STAFF REPORT
COMMUNITY DEVELOPMENT DEPARTMENT

HEARING DATE: February 23, 2021
TO: Planning & Zoning Commission
FROM: Sonya Allen, Associate Planner
208-884-5533
SUBJECT: H-2020-0047
Prescott Ridge – AZ, PP, PS, ~~ALT~~
LOCATION: South of W. Chinden Blvd. and east of N. McDermott Rd., in the North ½ of Section 28, Township 4N., Range 1W.
(Parcels: S0428233640, R6991222210, S0428120950, S0428131315, S0428131200, S0428211102)

A. Master Plan Conceptual Rendering & Medical Campus Conceptual Development Plan - REVISED

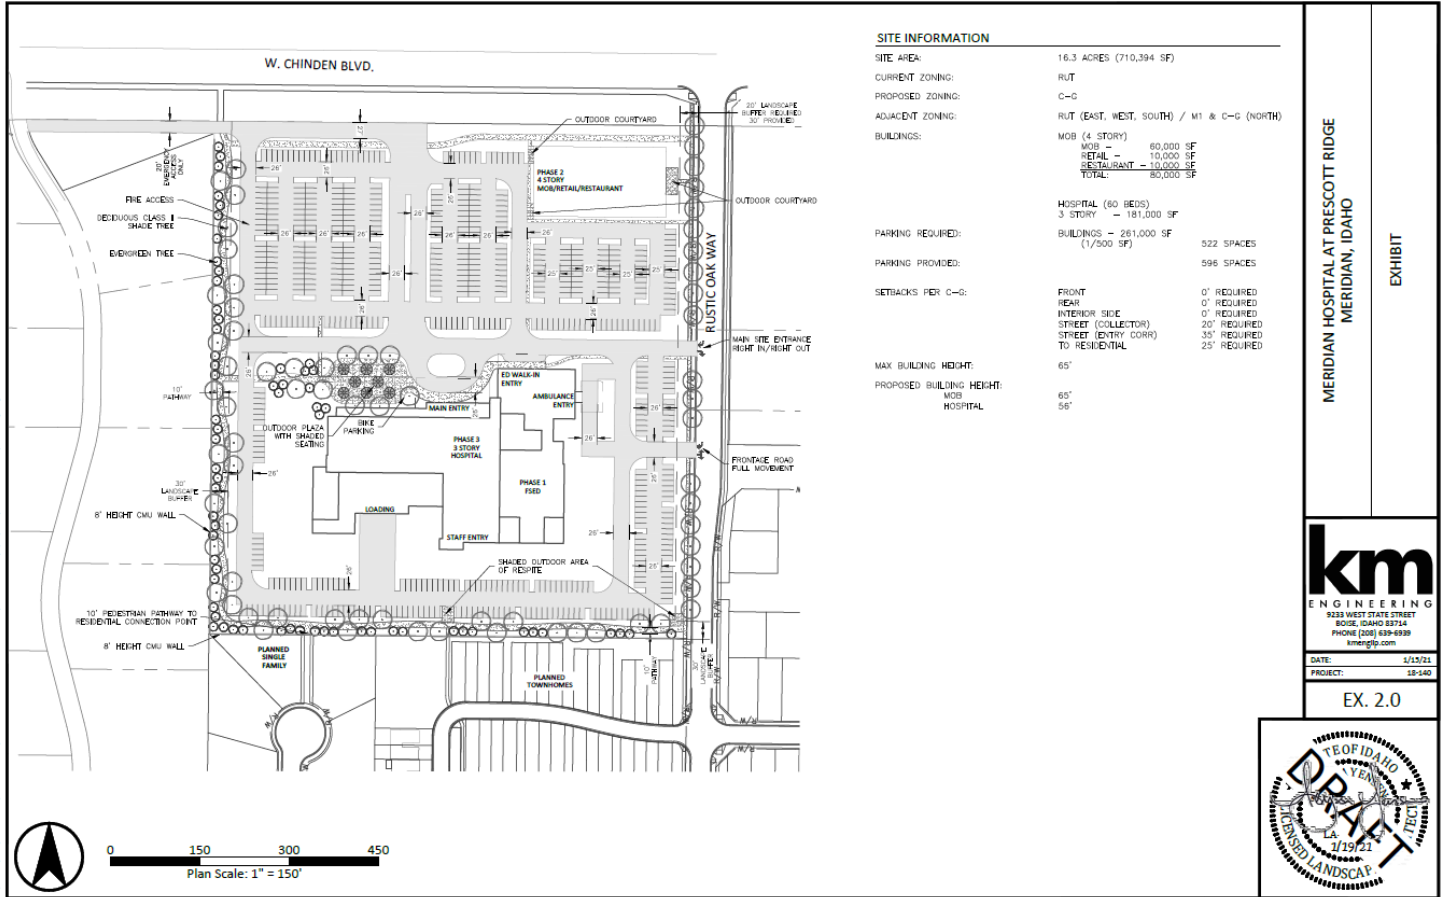
- b. Relocate the parking on the east side of the medical office building to the west side of the building and shift the building further to the east away from the adjacent residential properties (see revised concept plans in Section VIII.A);

Note: Although tree-lined trees are depicted, parkways with detached sidewalks are not proposed except for along the collector streets (i.e. N. Rustic Oak Way & McDermott Rd.) and on common lot end-caps; an east/west-oriented mew with landscaping is depicted within the townhome portion of the development which is also not proposed.

5. A frontage road parallel to W. Chinden Blvd./SH 20-26 shall be constructed as depicted on the conceptual development plan in Section VIII.A in accord with UDC 11-3H-4B.3e.

C. Preliminary Plat (date: 8/28/2020 10/21/20 11/20/20 12/22/20), Phasing Plan & Lot Layout Exhibit REVISED

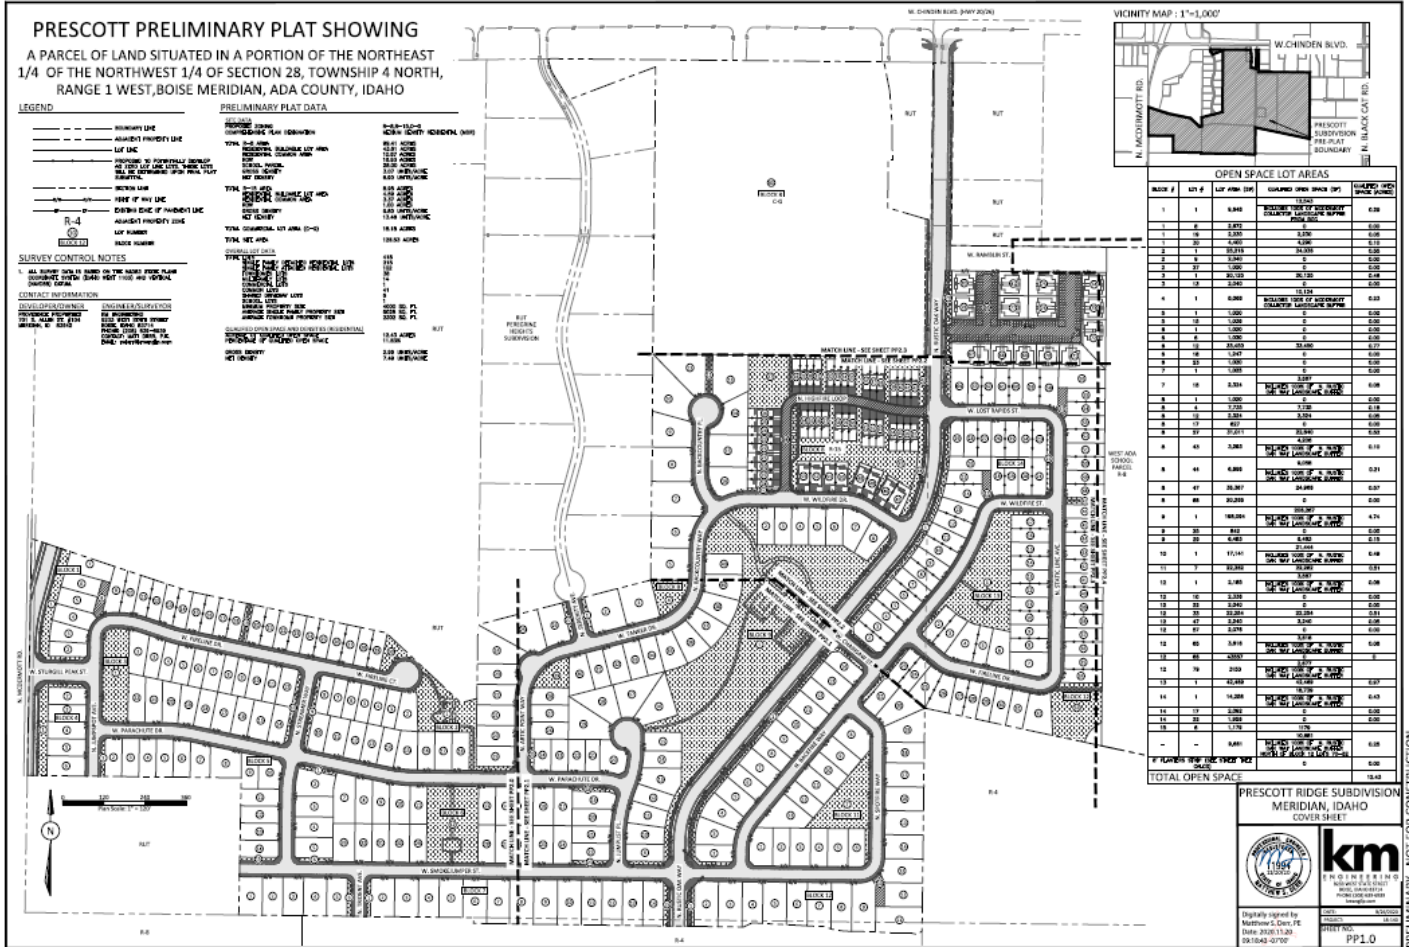
- d. Reduce the number of lots along the southern boundary to provide better transition to the R-4 properties planned to the south in The Oaks subdivision (lots were reduced by 5 along the south and southeast boundaries, see revised plat in Section VIII.C).

- ~~b. Remove Lot 1, Block 15 as it's ACHD right of way and cannot be platted as a common lot.~~
 - c. Depict cross-access/ingress-egress easements to adjacent MU-R designated properties to the west (Parcels # R6991221700 & R6991221600) and east (Parcel # R6991222101) in accord with UDC 11-3A-3A.2.

- ~~d. Depict lot numbers for common areas in the townhome portion of the development in Block 8.~~
 - e. Depict the easement(s) for the West Tap sub-lateral; if the easement(s) is greater than 10-feet in width, it should be placed in a common lot that is a minimum of 20-feet in width and outside of a fenced area, unless modified by City Council as set forth in UDC 11-3A-6E.

- k. If a dog park is proposed on Lot 1, Block 2, demonstrate compliance with the standards listed in UDC 11-3G-3C.1h.
- l. Depict a small tot lot on Lot 12, Block 6 rather than a large tot lot, consistent with that shown on the site amenities plan.

D. Landscape Plan (date: ~~8/26/2020~~ ~~10/9/2020~~ ~~11/19/20~~ ~~12/22/20~~) – REVISED

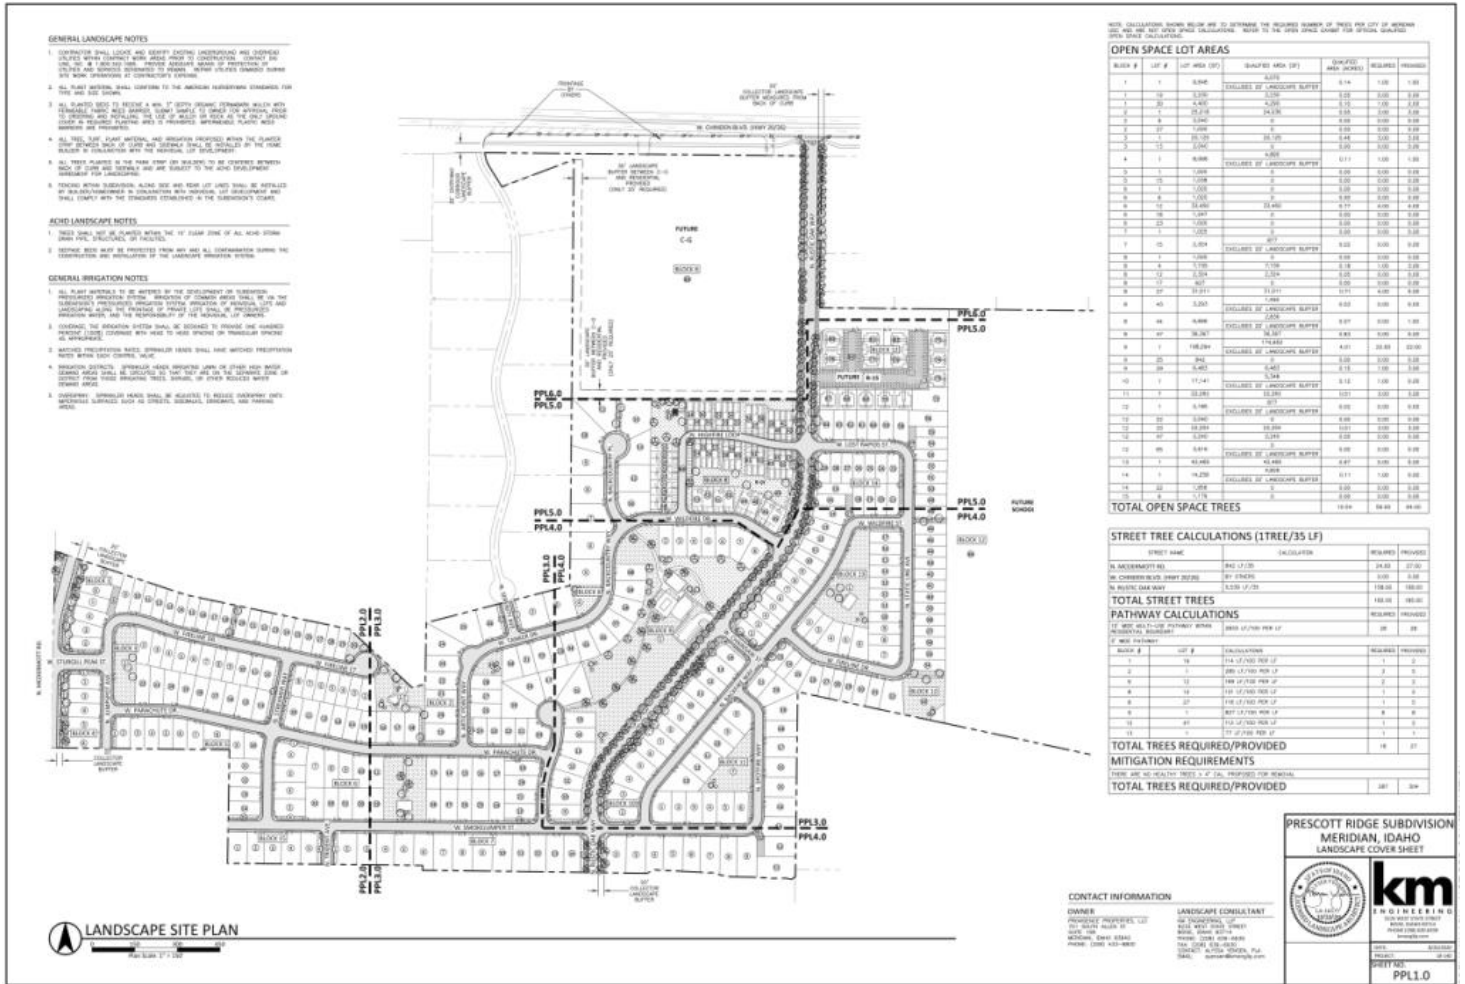
Parkways where provided are required to be landscaped in accord with the standards listed in [UDC 11-3B-7C](#). **The total linear feet of parkways with the required and proposed number of trees should be included in the Landscape Calculations table on the final plat landscape plan to demonstrate compliance with the required standards.**

Landscaping is required along all pathways in accord with the standards listed in [UDC 11-3B-12C](#). **The total lineal feet of pathways with the required and proposed number of trees should be included in the Landscape Calculations table on the final plat landscape plan to demonstrate compliance with UDC standards.**

Common open space is required to be landscaped in accord with the standards listed in [UDC 11-3G-3E](#). **The total square footage of common open space with the required and proposed number of trees should be included in the Landscape Calculations table on the final plat landscape plan to demonstrate compliance with the UDC standards.**

Fences abutting pathways and common open space lots not entirely visible from a public street is required to be an open vision or semi-private fence up to 6' in height as it provides visibility from adjacent homes or buildings per UDC 11-3A-7A.7. **Staff is concerned there is not enough visibility from the street of the common area on Lot 1, Block 2 located behind building lots and around Lot 37, Block 12 and recommends the fencing type is revised on the perimeter of these lots to comply with this standard.**

4. A minimum 30-foot wide buffer with an 8-foot tall CMU wall shall be provided along the western and southern boundaries of the site adjacent to residential uses as proposed on the landscape plan in Section VIII.D. Dense landscaping consisting of a mix of evergreen and deciduous trees, shrubs, lawn or other vegetative ground cover that results in a barrier that allows trees to touch at maturity is required per the standards listed in UDC 11-3B-9C. The block wall shall be decorative and have texture and a color complimentary to adjacent residential structures – plain CMU block is not allowed.

Revised rendering submitted after the Commission hearing that correctly depicts the 3-story (rather than 4-story) hospital building:

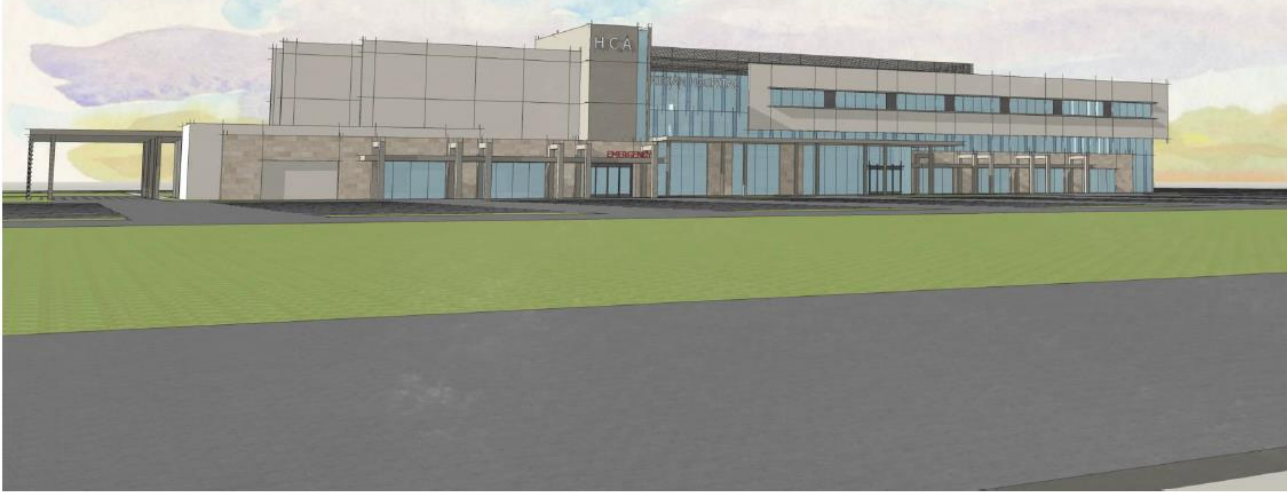
Conceptual renderings of the hospital and medical office buildings were submitted as shown in Section VIII.G. The hospital is proposed to be a 3-story building and the medical office building a 4-story building. **The elevations for the medical office building incorrectly depict a 3-story building; these elevations should be revised prior to the City Council hearing to reflect the correct number of stories.**
